Wednesday, February 2, 2022
Planning Commission

Planning Commission Agenda

Subject **A. CONSTRUCTION STANDARDS 22-01. Proposed amendments to Policy 4.39 of the Construction Standards.**

To: Mayor and City Council
From: Chris Thompson P.E., Public Works Director
Date: February 15, 2022
Re: Ordinance Construction Standards Revision (22.01)

Cost comparison for meter vaults / boxes

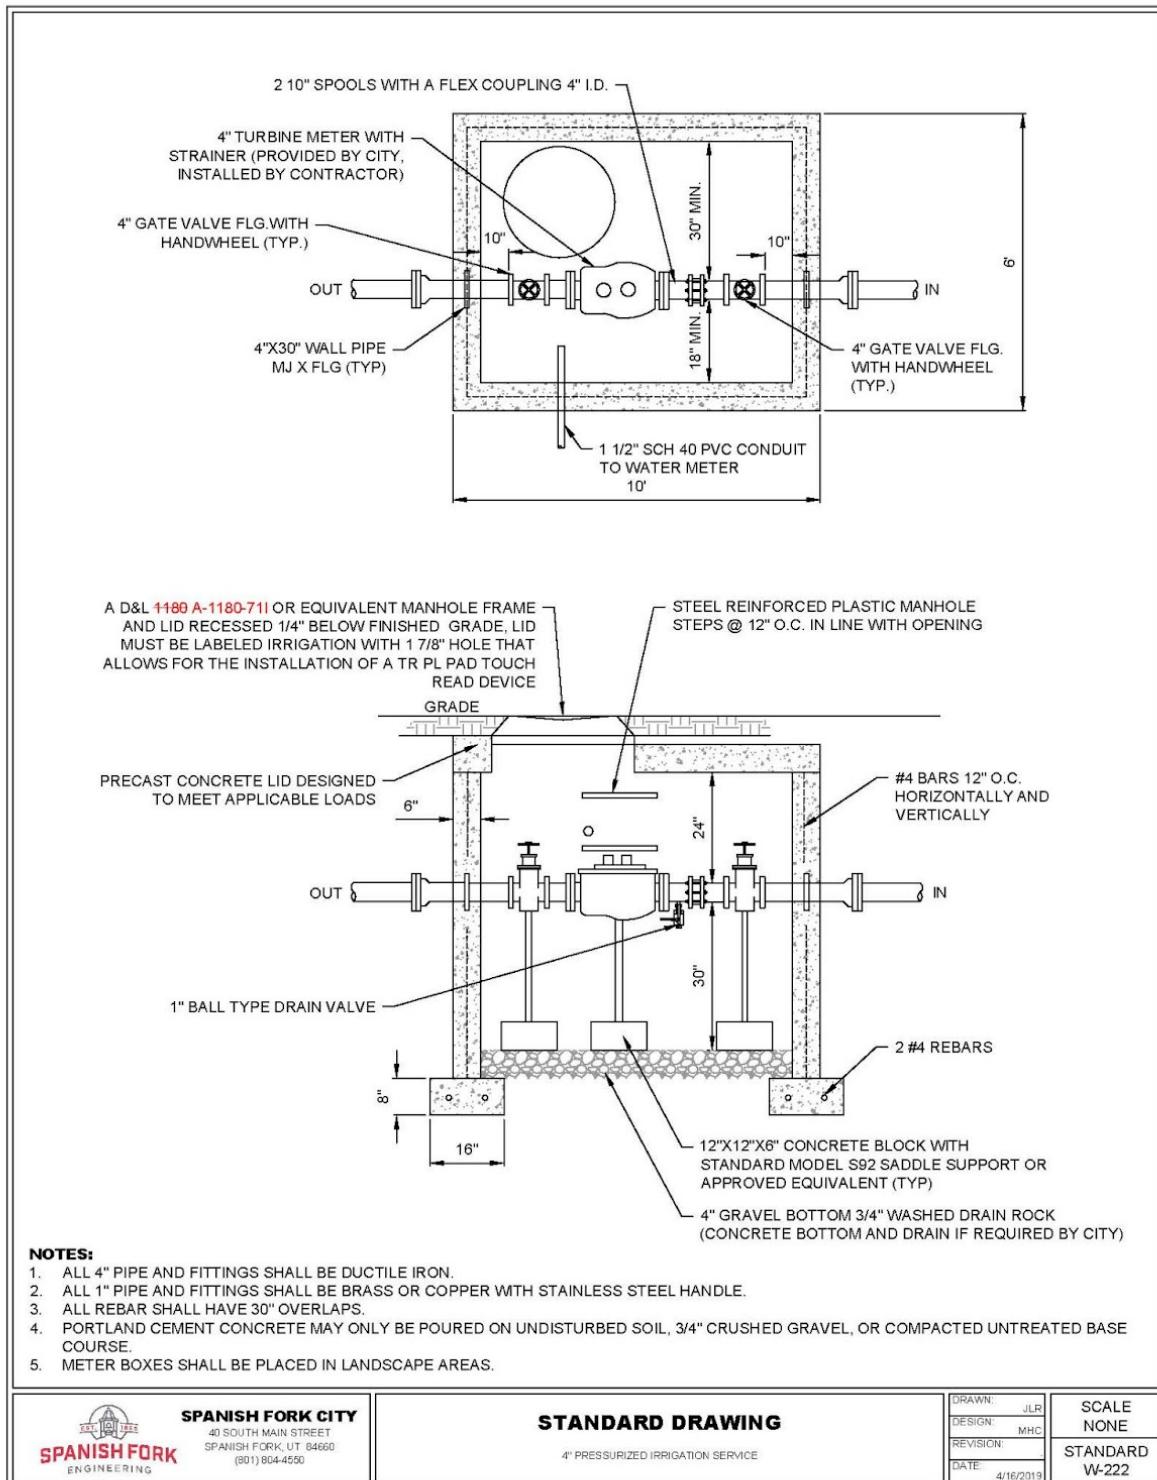
- Modifies standards W-214, W-215, W-218, W-219 & W-222 to call out the correct manhole lid.
- Modifies Concrete Collar to read $\frac{1}{8}$ " (max) instead of $\frac{1}{4}$ "
